UNITED STATES
DEPARTMENT OF THE INTERIOR
BUREAU OF LAND MANAGEMENT

SUNDRY NOTICES AND REPORTS ON WELLS
Do not use this form for proposals to drill or to re-enter an abandoned well. Use form 3160-3 (APD) for such proposals.

8. Well Name and No.
SWEETNESS 30 STATE FED COM 1H

CONDITIONS OF APPROVAL

13-5/8" 5M BOPE & Closed Loop Equipment Schematic

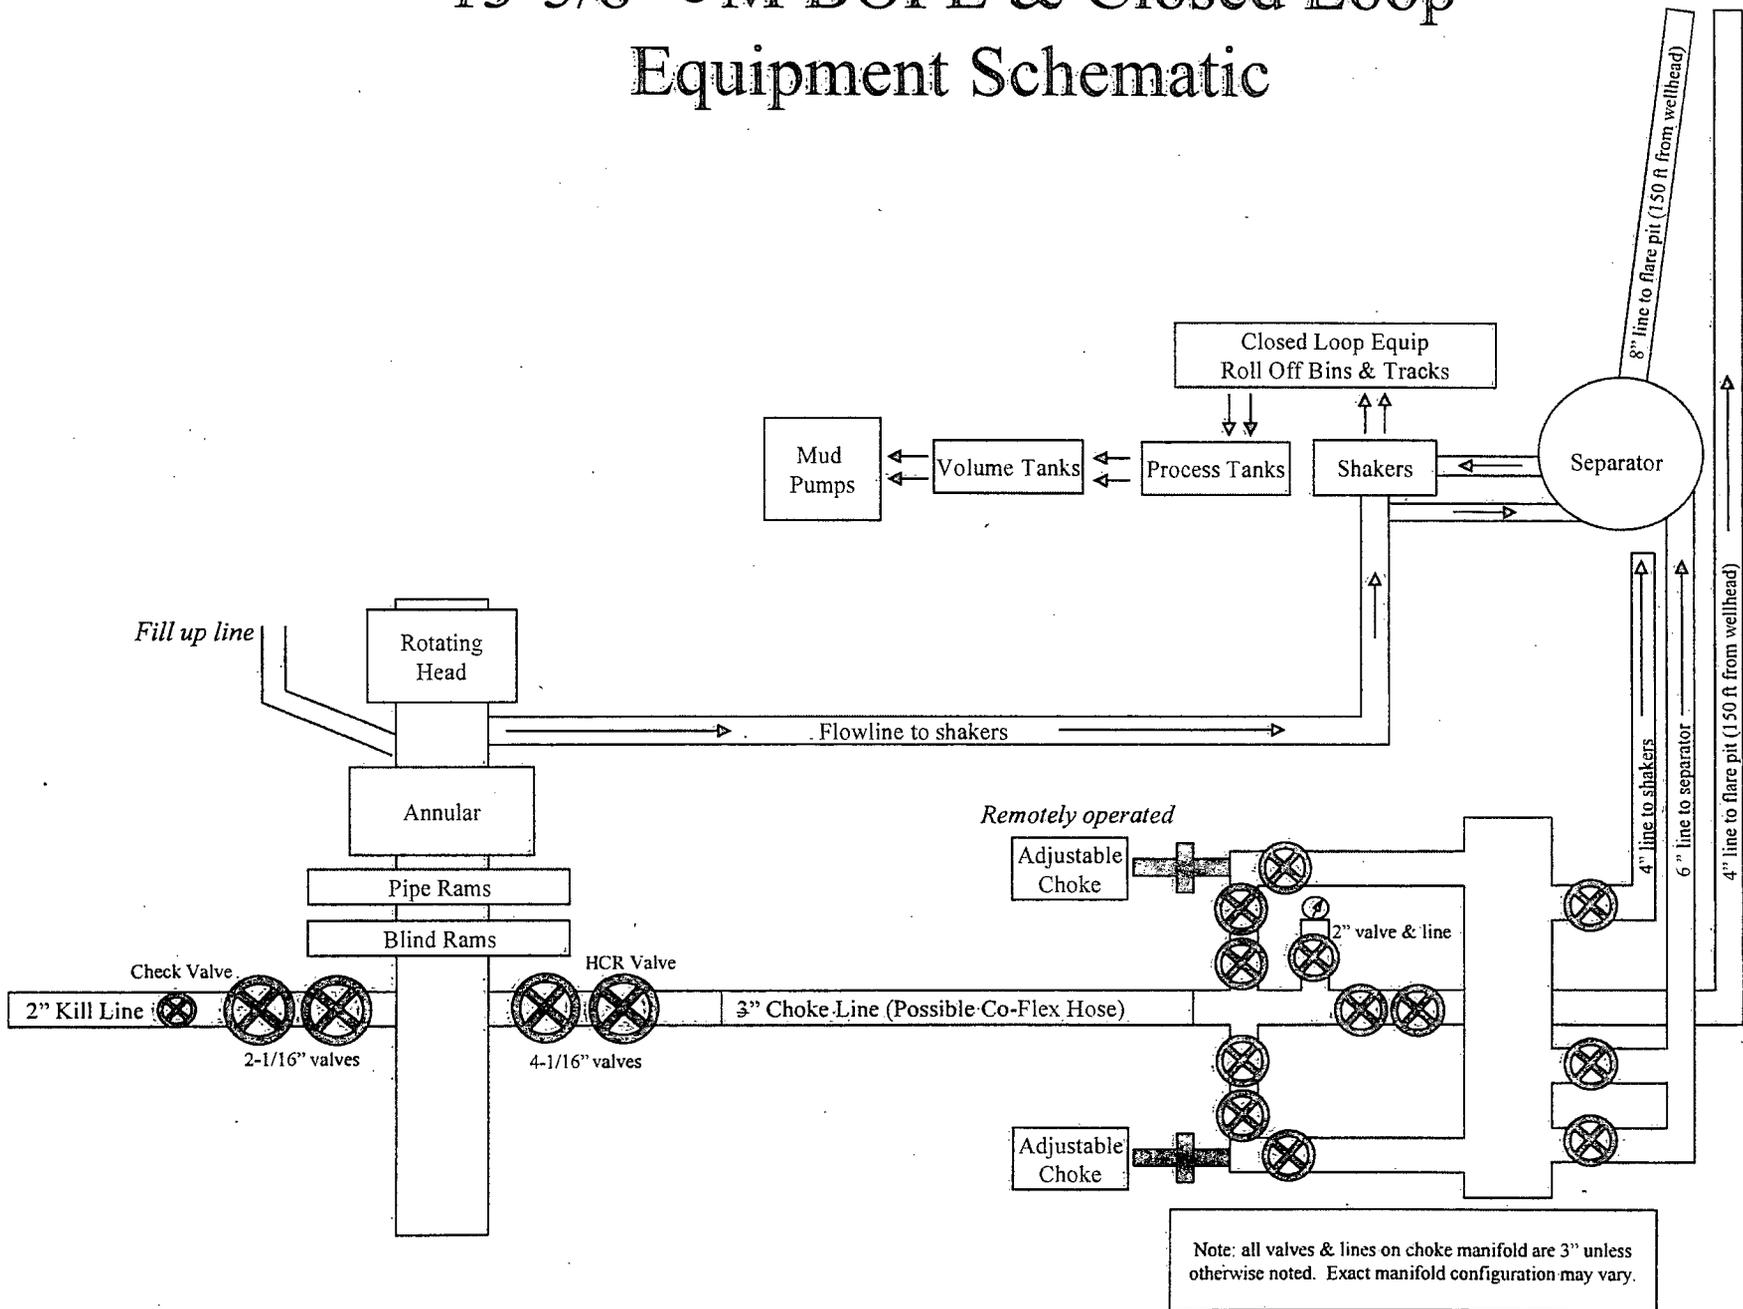
- Change the Pilot Hole depth from 9,426' to 11,850'.
- Change BOP from 3M to 5M.

See attached BOP schematic for 5M and pilot hole plug back narrative.

3. Minimum working pressure of the blowout preventer (BOP) and related equipment (BOPE) required for drilling below the surface casing shoe shall be **5000 (5M) psi. 5M system requires an HCR valve, remote kill line and annular to match. The remote kill line is to be installed prior to testing the system and tested to stack pressure.**
